### Agenda Item 3 1040 Anna Lane New Residence

#### 1040 Anna Lane

Consideration of a request for approval of construction of a single family residence and attached garage on a vacant lot. Approval of a conceptual landscape plan and overall site plan is also requested.

# Agenda Item 4 Deerpath Park Concessions, Restroom, Storage & Maintenance Buildings

#### PROPOSED NORTH ELEVATION

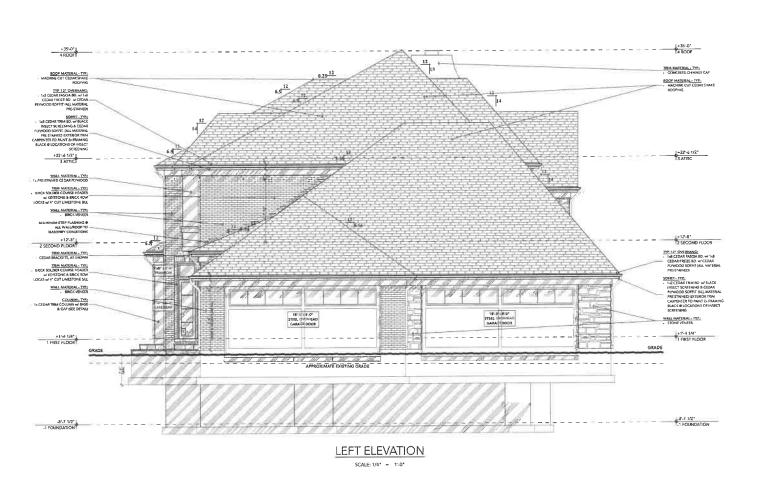
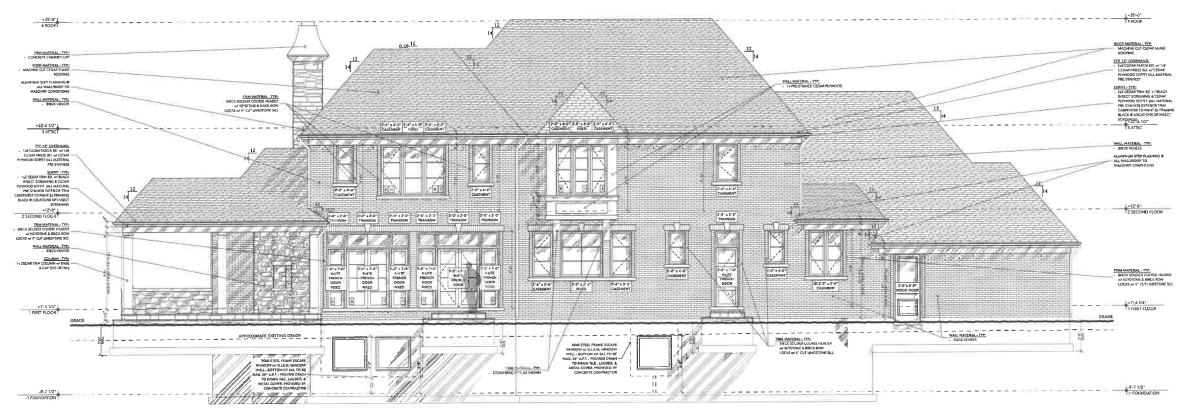
The proposed residence reflects a primary two-story mass with smaller masses that step down in height on the north and south sides. On the front elevation, the home reflects steep hip roof forms with the entrance highlighted by a two-story gable element that projects from the primary mass of the home. The side elevations of the home present a combination of steep and shallow hip roof forms. A very large and unbroken roof mass is proposed above the garage on the west side of the home.

- Staff recommends further study of the roof forms and pitches with the goal of simplifying the roof lines and achieving a design that is more consistent around the home.
- Staff recommends further study of the roof form above the garage and consideration of design elements to visually break up the large roof mass.

- 1. Conduct further study and make refinements as follows:
  - a. Simplify the roof forms and pitches to achieve a design that is more consistent around the home.

- b. Add design elements to the roof form above the garage to visually break up the large roof mass.
- 2. All modifications to the plans including those detailed above and any others made in response to Board direction or as the result of final design development, shall be clearly called out on the plan and a copy of the plan originally provided to the Board shall be attached for comparison purposes. Staff is directed to review any changes, in consultation with the Chairman as appropriate to determine whether the modifications are in conformance with the Board's direction and approval prior to the issuance of any permits.

#### PRELIMINARY SITE GRADING PLAN

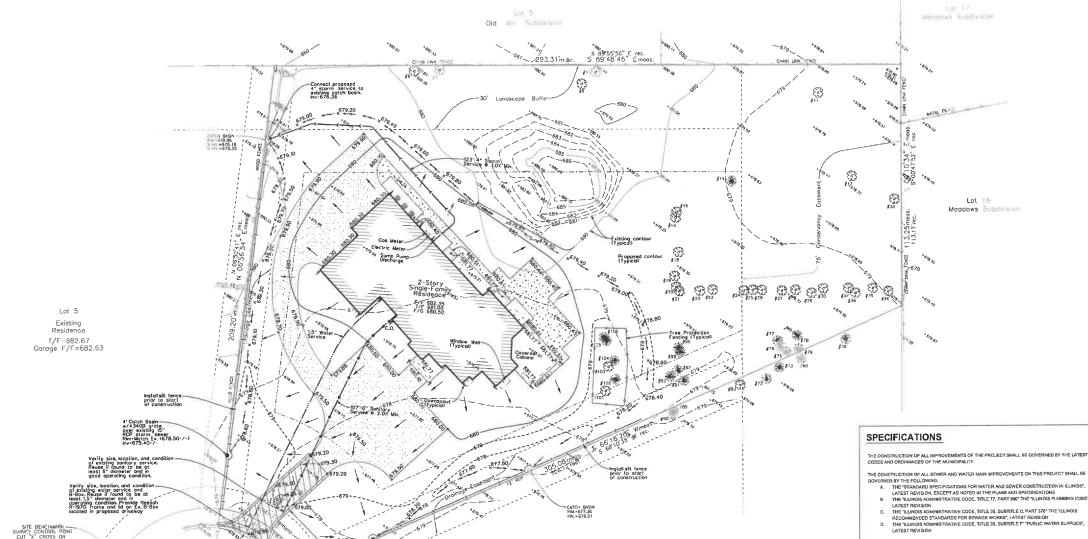
Potential concern on standing water/drainage issues - In the past we have had issues with standing water/drainage in the area. For example, when our home at 1070 W Anna Lane was built, it seems the grade change resulted in standing water on the north and west ends of our property that effectively "drown" 10 – 15 majestic 30 - 40 ft. tall pine trees that died and had to be removed. As a result, we had to undertake a costly project to add soil, drainage and a retaining wall. Another example, the property to the north of the 1040 W Anna Lane used to have a large pool of standing water perhaps 30 – 50 ft in diameter on the southeast corner of their lot just beyond the 1040 W Anna Lane property line. Given this history, I believe it would be in the best interest of all parties to avoid any unintended consequence that the new construction/grading results in drainage/standing water issues on 1040 W Anna Lane, the neighboring properties and common areas in the Cul de Sac.

- 5. At the time of submittal for a building permit, detailed drainage and grading plans must be submitted. No grading or filling shall be permitted except the absolute minimum necessary to meet accepted engineering standards and practices.

LANDSCAPE PLAN 1040 W ANNA LANE LAKE FOREST, IL

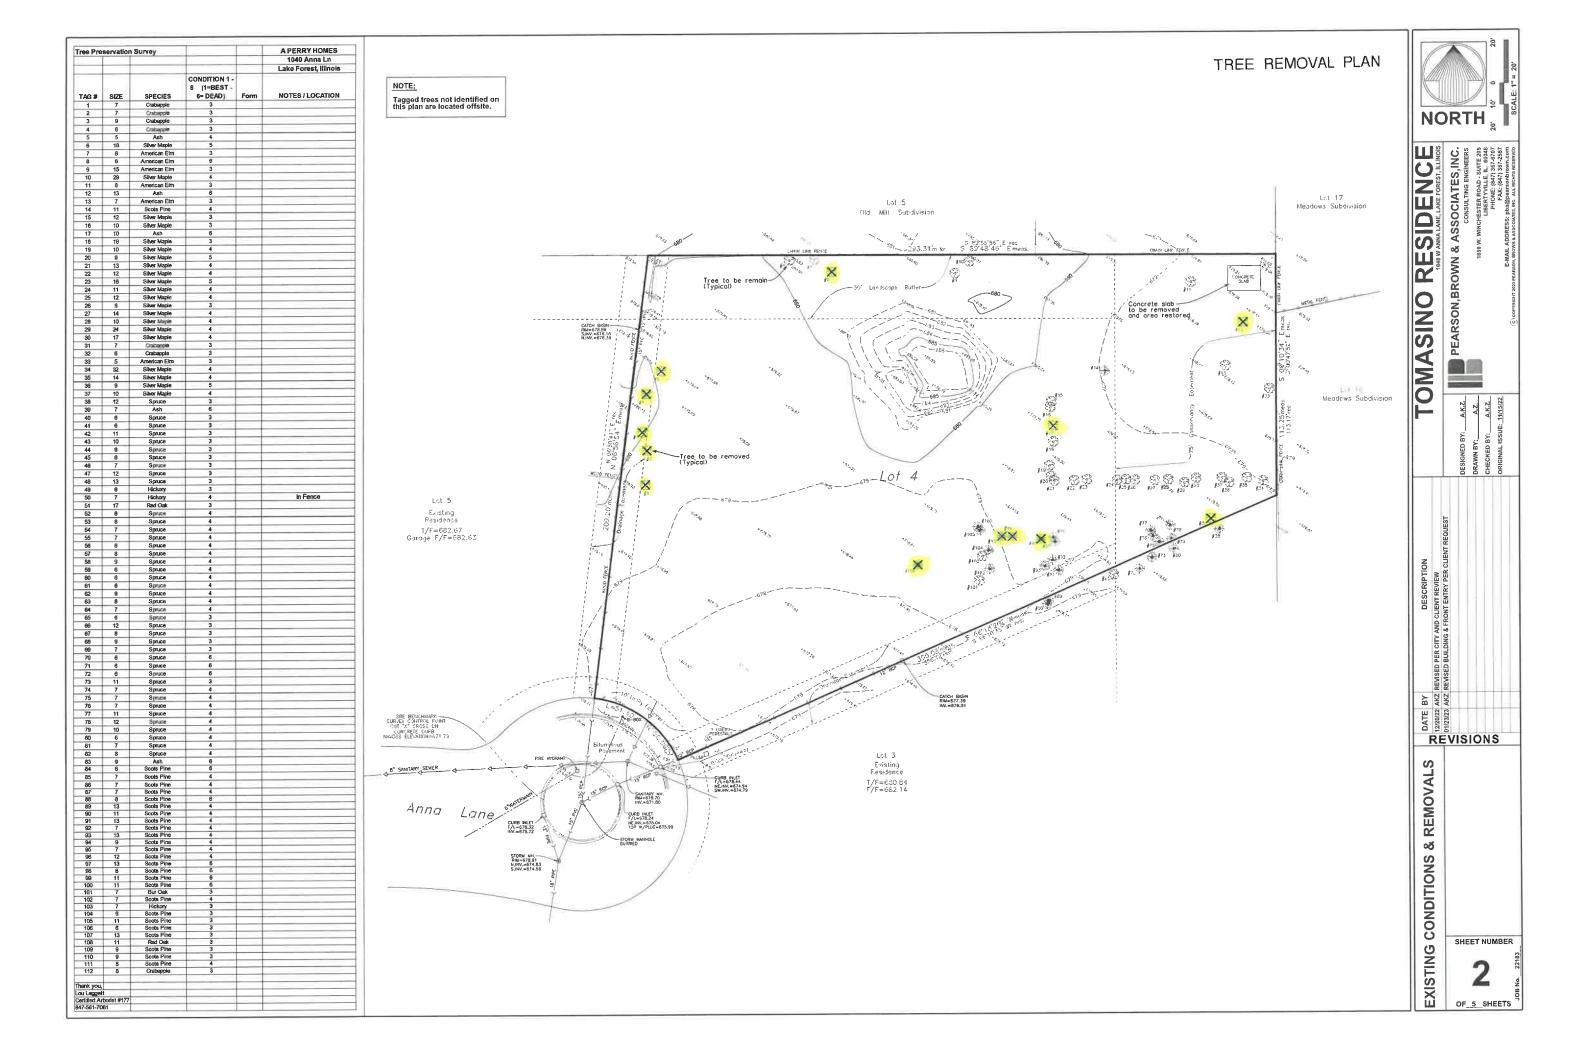
As currently proposed, a total of thirteen trees are proposed for removal. The trees proposed for removal include four Ash, four Crabapple, one Elm, three Pine and one Oak tree. Most of the trees proposed for removal are dead. Based on the species, size and condition of the trees proposed for removal, a total of 11 replacement inches are required and must be planted on site.

The preliminary landscape plan submitted by the petitioner reflects plantings around the foundation of the home, along the front drive and along the north and south property lines. The proposed plantings include a mix of shade, evergreen and ornamental trees including Maple, Spruce, Birch, Arborvitae, Serviceberry, Redbud, and Dogwood trees. The plantings currently reflected on the landscape plan satisfy the minimum criteria for landscaping and the required replacement inches.

- 3. Prior to the issuance of a building permit, a detailed landscape plan shall be submitted and will be subject to review and approval by the City's Certified Arborist. The plan shall, at a minimum, meet the landscaping standards for new residences detailed in the Code and all required replacement tree inches to account for trees removed to the extent possible using good forestry practices. The landscape plan must include the quantity, species, and size at the time of planting for all new landscaping.
